Road Safety Audit Review

Town:	Barre City	Date Reviewed:	September 3, 2015
Route:	Prospect St and Berlin St Intersection	Mile points:	Prospect: 0.539, Berlin: 0.000

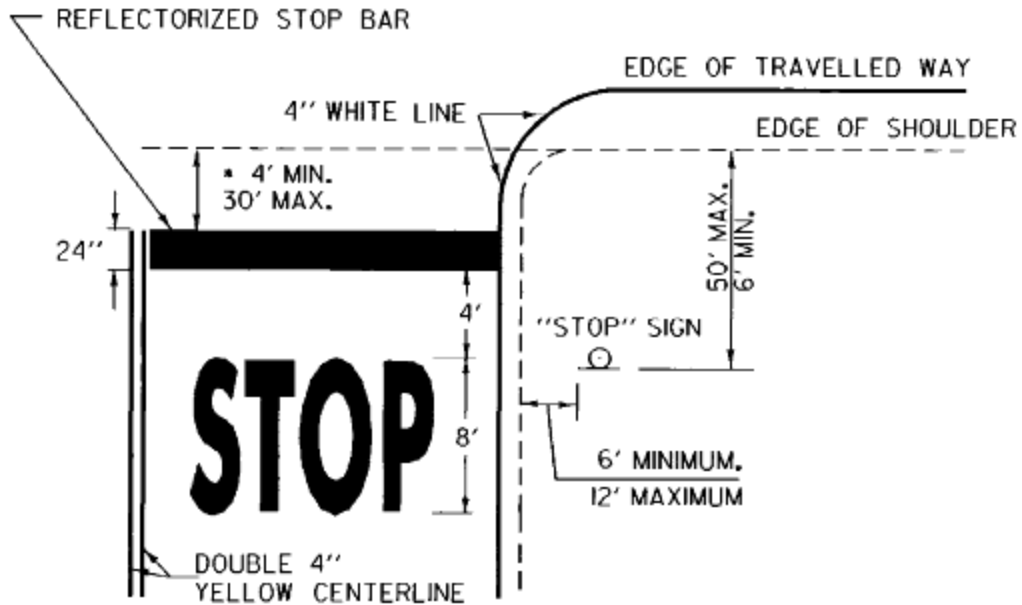
Concern: Corner Sight Distance Issue, Northwest Quadrant

The corner sight distance when stopped on Berlin Street and looking to the right (west) is impeded by the presence of a fence covered with leaves and of a bush.

Ensure that the stop bar is located four feet from the edge of the road to maximize corner sight distance and that it is visible and refreshed on a yearly basis as needed.

Provide a clear sight triangle by removing any obstructions that are located inside the boundaries of the triangle.

Note, Intersection Sight Distance (ISD) for 25 mph is 280 ft, for 30 mph, 335 feet and 390 ft for 35 mph as per AAHSTO.
